DRAINAGE INFORMATION SHEET

PROJECT TITLE: LUXURY INN ZONE ATLAS/DRNG. FILE #: K18 / D66

RE: RESUBMITTAL FOR ENGINEER CERTIFICATION FOR LUXURY INN  
(K18-D66) CERTIFICATION STATEMENT DATED 11/3/95.

GRADING & DRAINAGE PLAN  
 LUXURY INN  
 ALBUQUERQUE, NEW MEXICO

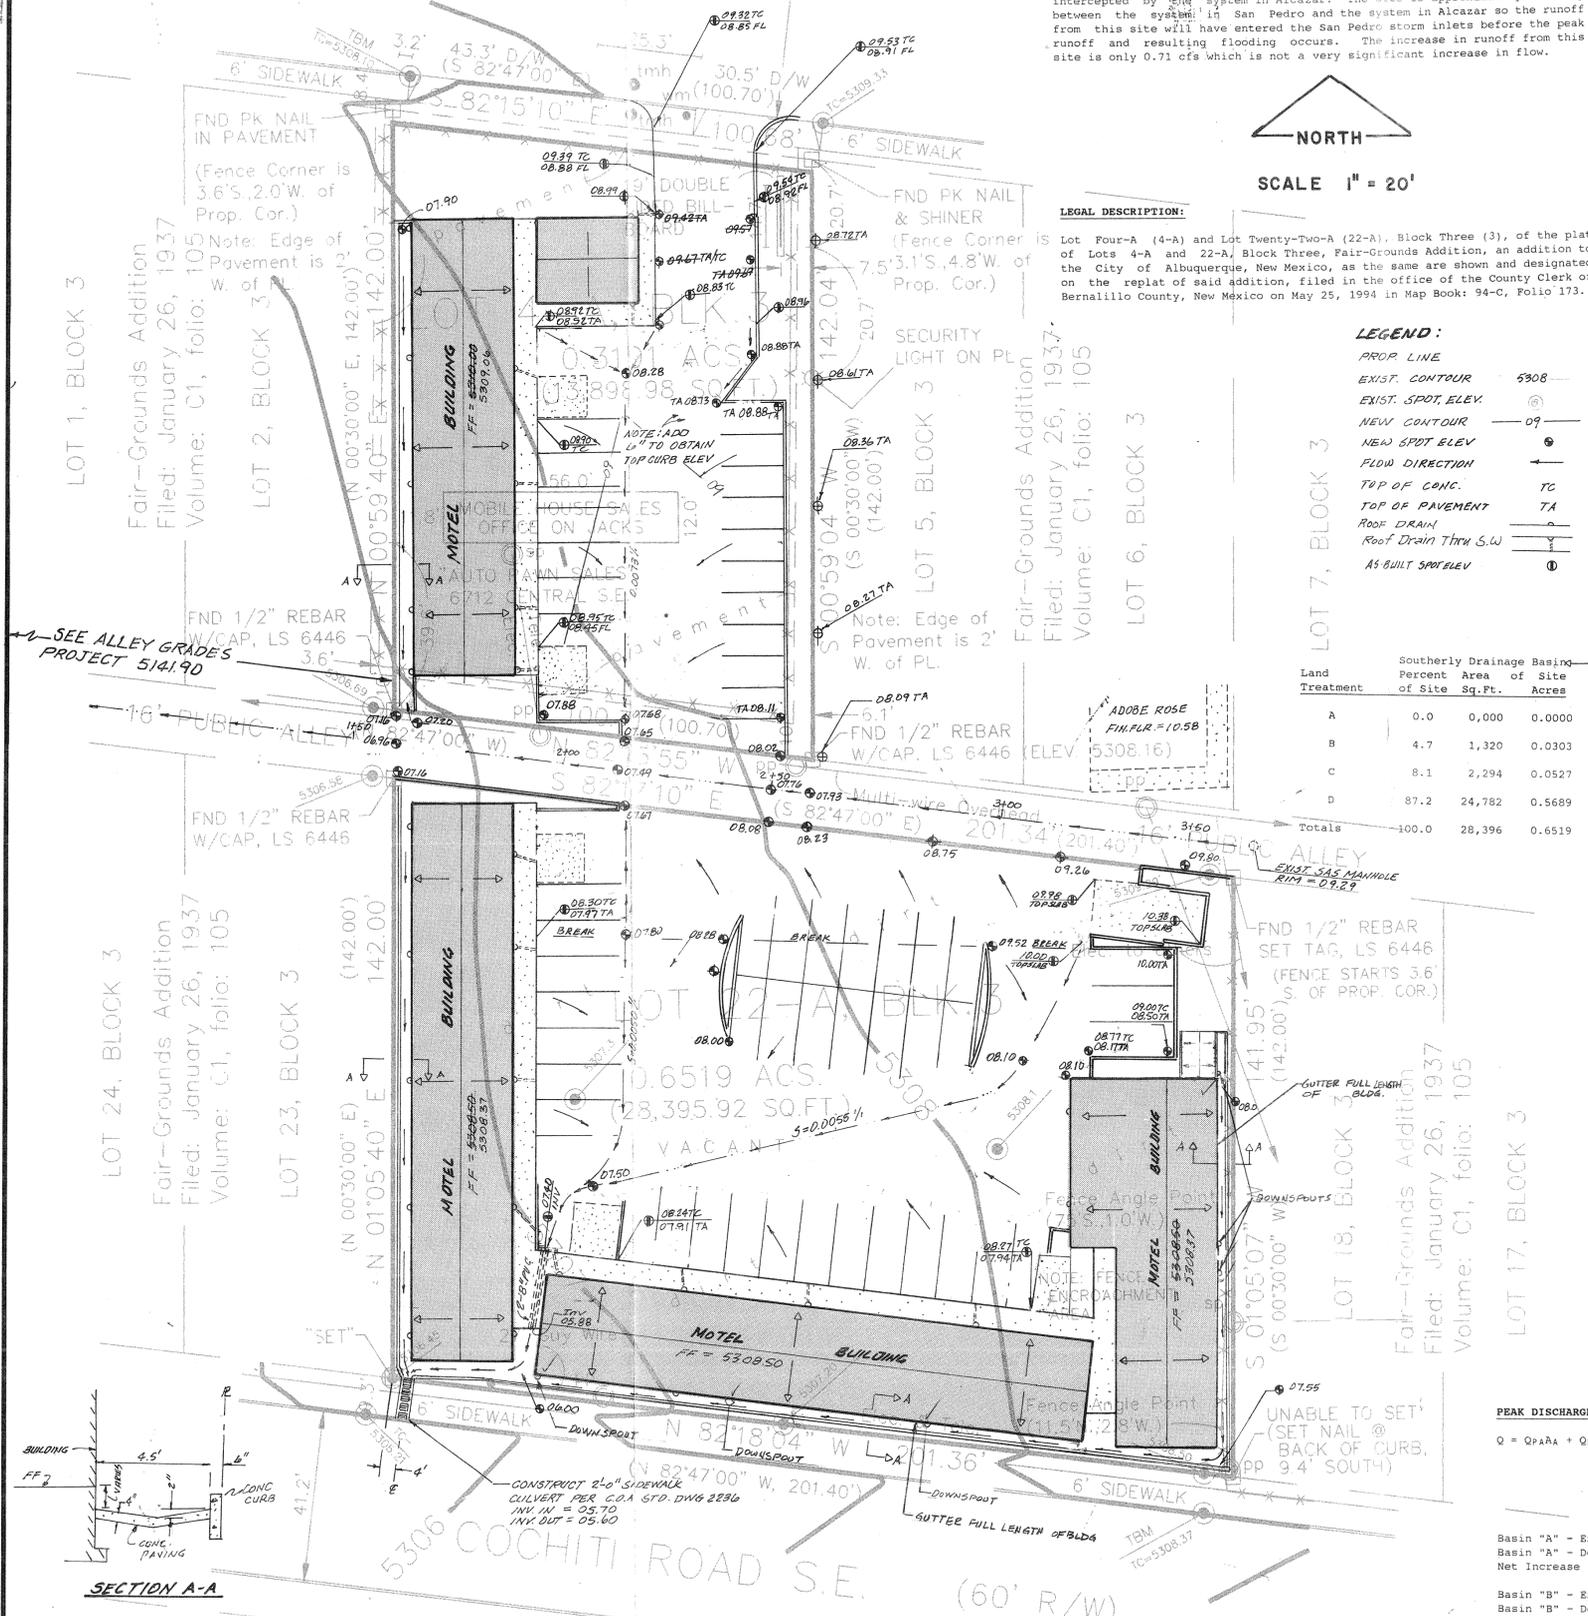
ENGINEER'S CERTIFICATION:  
 I hereby certify that I have personally inspected the site and that finish floor elevations and certain spot elevations have been shot by others at my request, and that the site and all drainage facilities are in substantial compliance with the approved grading and drainage plan, engineer's stamp dated 9-28-94 (revised 2-17-95), with the following exceptions:

- The vacated alley, crossing through the middle of the motel parking lot from east to west has not been paved because the vacation was to have been finalized in DRB on 3/28/95. This will be completed before the lapse of a 30-day temporary C.O. in conjunction with the other alley paving described in paragraph 2 below.

- The alley between the motel parking lot and Florida Street has not been constructed. The contractor is in the process of obtaining a work order and will have it complete before the lapse of a 30-day temporary C.O.

- The sidewalk culvert on Cochiti is under construction as of this date. The Contractor has obtained his permit and has removed the existing curb and gutter and sidewalk. The work will be completed with inspection green tags before the lapse of a 30-day temporary C.O.

- The drainage channel between the motel and Cochiti Drive and on the east side of the southerly motel complex has been rough graded but has not been paved. This is scheduled to be completed within the next few days and will be completed before the lapse of a 30-day temporary C.O.

- The concrete swale has been constructed along the west side of the buildings with a 2" invert but the concrete curb adjacent to it has been deleted. No downspouts have been provided and a drip edge is proposed to replace all gutters and downspouts. If this is unacceptable it can be resolved prior to the lapse of a 30-day temporary C.O.

Based on the information provided on your November 6, 1995  
resubmittal, Engineer Certification for the above referenced site  
is acceptable.

ENGINEER'S CERTIFICATION:  
 The above items 1 through 5 have all been satisfactorily completed and all on-site facilities are now in substantial compliance with the approved grading and drainage plan. The gutters have been installed along the rear side of all buildings. The number and location of downspouts on the south and east side are different than the approved plan but are shown as installed.
